**UNITED STATES
NUCLEAR REGULATORY COMMISSION**
WASHINGTON, D.C. 20555-0001

FACILITY: Donald C. Cook Nuclear Plant, Units 1 and 2

SUBJECT: SUMMARY OF AUGUST 26, 2009, CATEGORY 1 PUBLIC MEETING VIA CONFERENCE CALL TO DISCUSS RESPONSES TO GENERIC LETTER 2004-02 REQUESTS FOR ADDITIONAL INFORMATION (TAC NOS. MC4679 AND MC4680)

DRAFT
Response to June 18, 2009 Request for Additional Information (RAI)
To Support August 26, 2009 Teleconference Between
Nuclear Regulatory Commission (NRC) And D. C. Cook Nuclear Plant (CNP)

Figure 7.a-1: Data Erosion Rate and Predicted Cumulative % Weight Loss Curve (Thermo-12™ Gold)

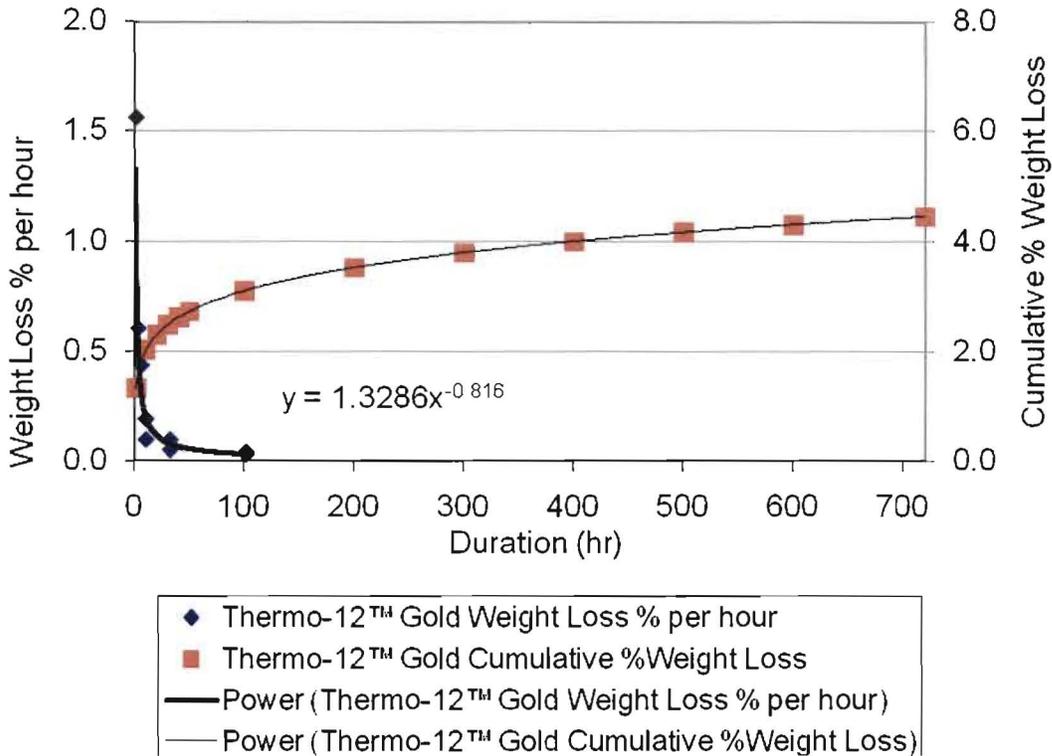
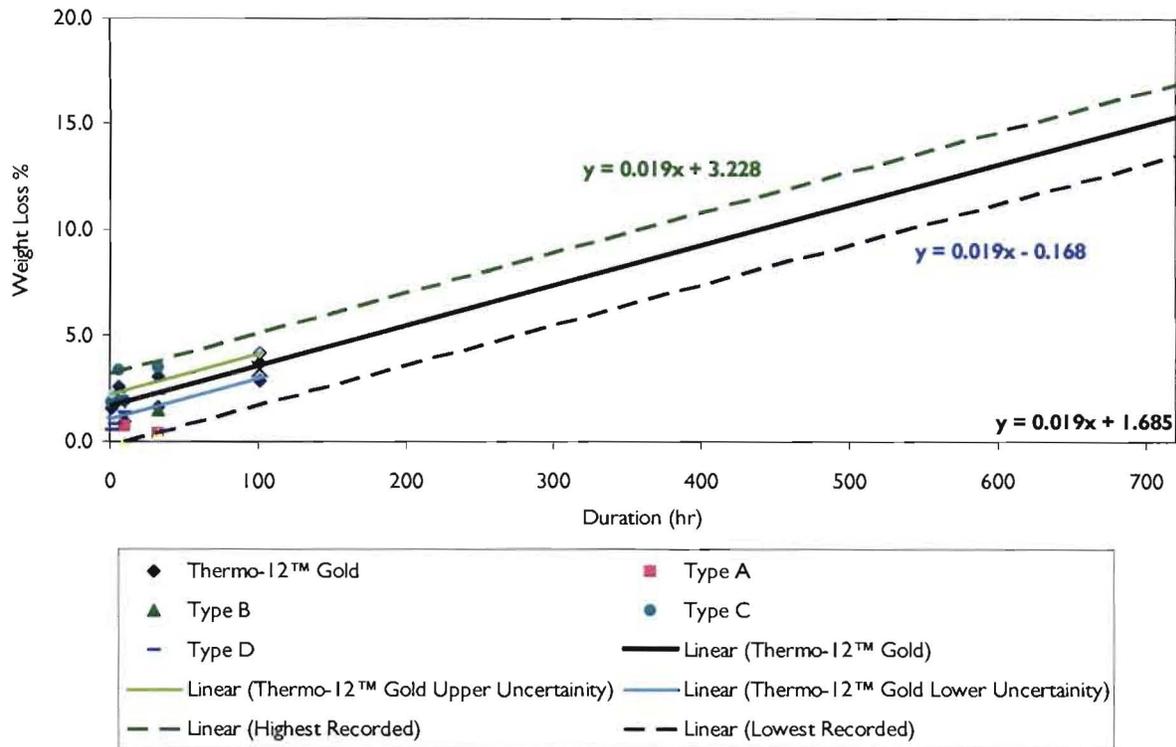
7. *Please provide additional information concerning the erosion testing of calcium silicate insulation and Marinite board, including the following items:*
 - a) *The basis for not accounting for erosion and dissolution effects in combination. The presence of chemicals in the test fluid may enhance the erosion rate, and, conversely, a high erosion rate may lead to increased dissolution.*

Extending the curve for cumulative % weight loss, the weight loss at 720 hours is 4.46%. Although the data plotted above indicates that the erosion rate may decrease with time, a linear curve fit was applied to the data as a more conservative method of extrapolation due to its application of a constant erosion rate as opposed to a power curve fit. Figure 3.2-2 of Cal-Sil Flow Erosion Testing Report (Figure 7.a-2) represents the linear curve fit. In addition to Thermo-12™ Gold Cal-Sil cumulative erosion, also displayed are values for four types of plant provided Cal-Sil cumulative erosion.

The curve fit of Thermo-12™ Gold was used to determine the total Thermo-12™ Gold erosion at the recirculation mission time of 30 days (720 hours) as obtained by extrapolation. The total weight loss of Thermo-12™ Gold Cal-Sil samples at 30 days is (15.37 ± 0.59)% (using the equation $y = 0.019x + 1.6854$).

The upper and lower bounds of the weight loss as a function of time are calculated by sliding the linear curve fits up and down to the points that have the greatest difference between the measured value and the linear curve fit. These upper and lower bounding curve fits are used to determine the upper and lower bounding values of total Cal-Sil erosion at the recirculation mission time of 30 days (720 hours) i.e. 13.512% to 16.91% of initial mass.

2. The method of calculating the Cal-Sil and Marinite flow erosion at 30 days is highly conservative:
 - a. Extending the curve for cumulative weight loss, the weight loss at 30 days for Thermo-12™ Gold is 4.46% (As shown in Figure 7.a-1).

- b. Although the data plotted in Figure 7.a-1 indicates that the erosion rate may decrease with time, a linear curve fit that was applied to the data as a more conservative method of extrapolation due to its application of a constant erosion rate as opposed to a power curve fit (As shown in Figure 7.a-2). The total weight loss of Cal-Sil samples calculated in this manner at 30 days is (15.37 ± 0.59)%.

- c. These upper and lower bounding curve fits are used to determine the upper and lower bounding values of total Cal-Sil erosion at the recirculation mission time of 30 days i.e. 13.512% to 16.91% of initial mass.

Figure 7.c-1: Average velocity in non-transport regions for small pieces of Cal-Sil and Marinite

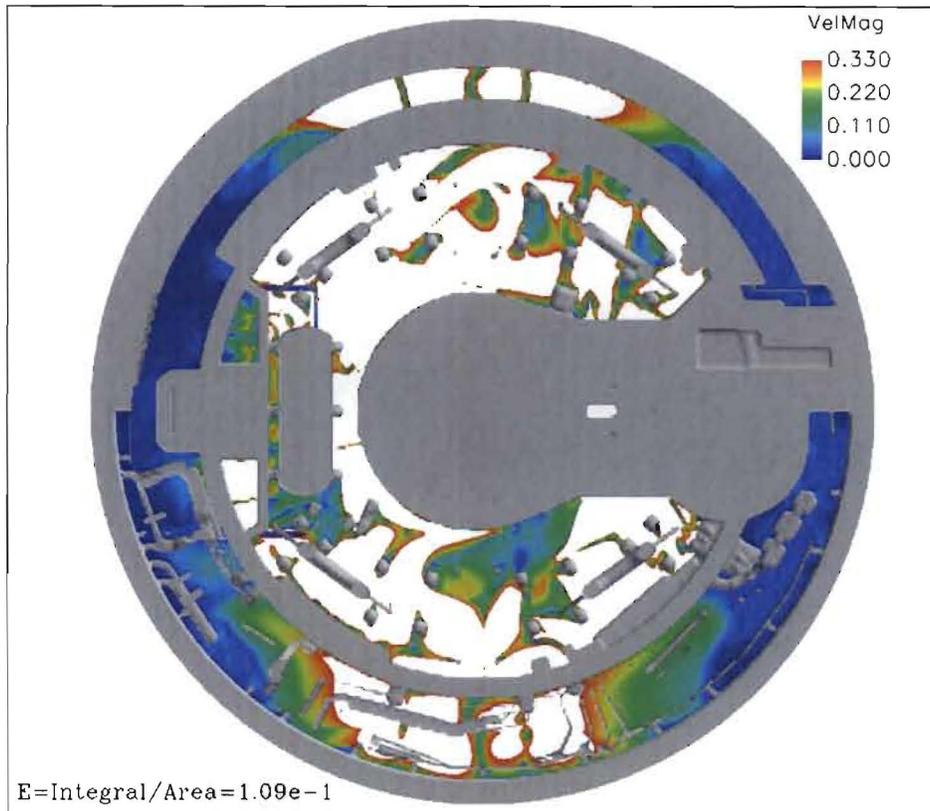
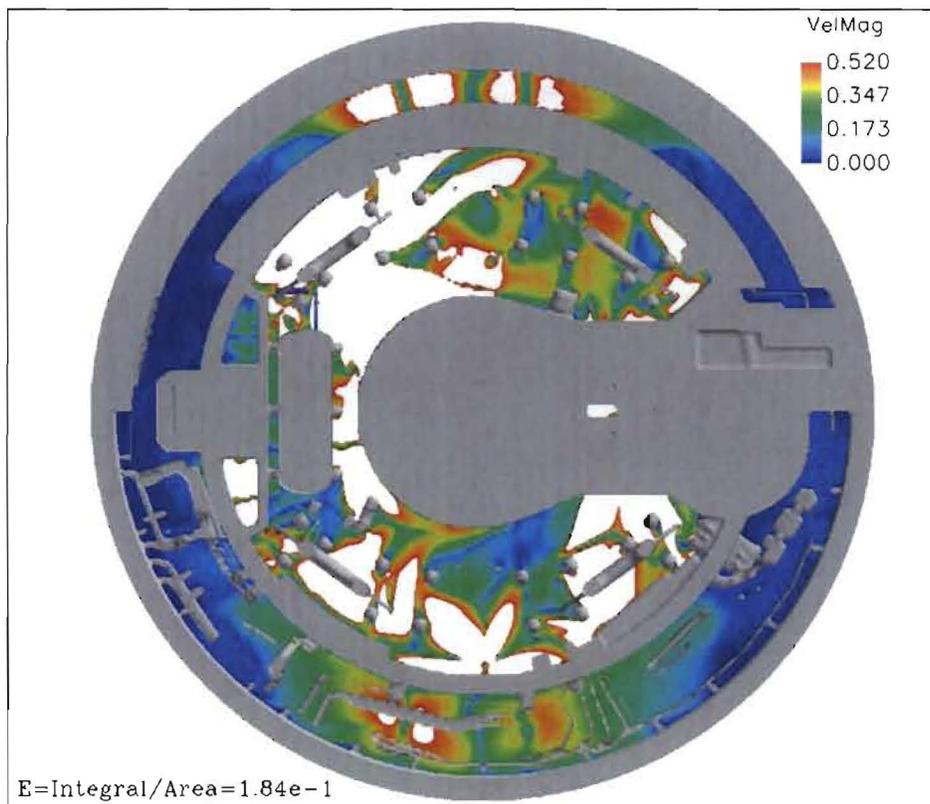
- c) *The basis for using a velocity of 0.4 ft/s, since calcium silicate pieces larger than those tested (i.e., in the large piece category) would not transport at this velocity based on the metric of 0.52 ft/s cited in Table 3e1-5 in the February 29, 2008 supplemental response. As a result of exposure to higher velocity flows than tested, erosion from settled large pieces of calcium silicate could be underestimated.*

The tumbling velocity that was used for small pieces of Cal-Sil and Marinite debris is 0.33 ft/s, and the tumbling velocity that was used for large pieces of Marinite debris is 0.52 ft/s. Since these pieces of debris would transport in any regions of the pool where the velocities are higher, the erosion would apply to debris that does not transport in the lower velocity regions. The recirculation pool CFD results from the limiting break case (Loop 4) were analyzed to determine the average velocity in the non-transport regions. As shown in Figure 7.c-1 and Figure 7.c-2, the average velocity in the non-transport regions was determined to be 0.11 ft/s for small pieces of Cal-Sil and Marinite, and 0.18 ft/s for large pieces of Marinite. Since these velocities are significantly lower than the 0.4 ft/s velocity used for the erosion tests, the erosion testing can be conservatively used for both the small and large pieces of Cal-Sil and Marinite at D.C. Cook.
